Re: Indian Point Unit No. 2
Docket No. 50-247

Subject: Response to the Staff's Questions Regarding the Root Cause Evaluation for
Steam Generator Tube Rupture Event of February 15, 2000 (TAC No.
MA8219)

Response to Root Cause Evaluation Issues Nos. 2, 6, 14 and 16

**Consolidated Edison Company of New York, Inc.
Indian Point Unit No. 2
Docket No. 50-247
June 2000**

Figure 6
SG4, U-bend, Tube R2C5, Crack 1 - 1997
NDE Depth vs. Axial Length

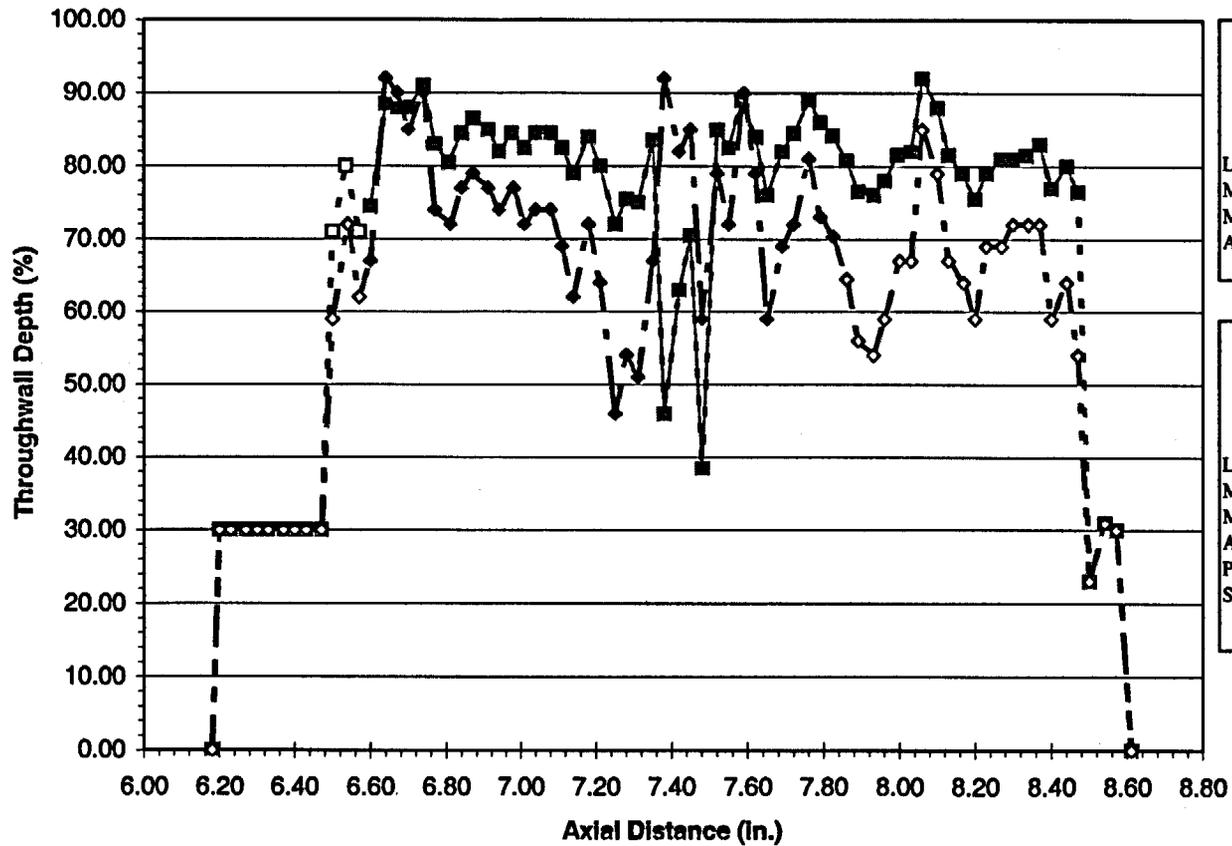
Section 2 states that inability to detect the precursor indication in R2C5 due to noise was the principle cause of the leakage event and that the growth rate of the indication between 1997 and 2000 was moderate and not a principle cause. Given the low voltage response of the 1997 signal and the high signal to noise, what level of accuracy can be assumed for the depth of the 1997 indication? On what basis?

How does the inferred growth rate of this indication compare to expected growth rates based on comparable industry experience and laboratory crack growth data (e.g., NUREG/CR-5752)?

The structurally significant part of a crack profile is the deepest section that results in the lowest burst pressure for the indication. This is called the burst effective length or profile in Figure 6. The two depth estimates result in burst effective average depths between about 73% and 80% or about a 7% difference between the two estimates. The standard deviation for sizing of +Point average depths is typically between 7% and 10%, which is consistent with the two depth estimates. Benchmark analyses to predict the February 2000 leakage event indicate that the best estimate profile of Figure 6 is more likely than the alternate estimate. Based on all evaluations, the alternate estimate of Figure 6 is a lower bound estimate, and the most likely estimate is close to the best estimate or potentially slightly deeper.
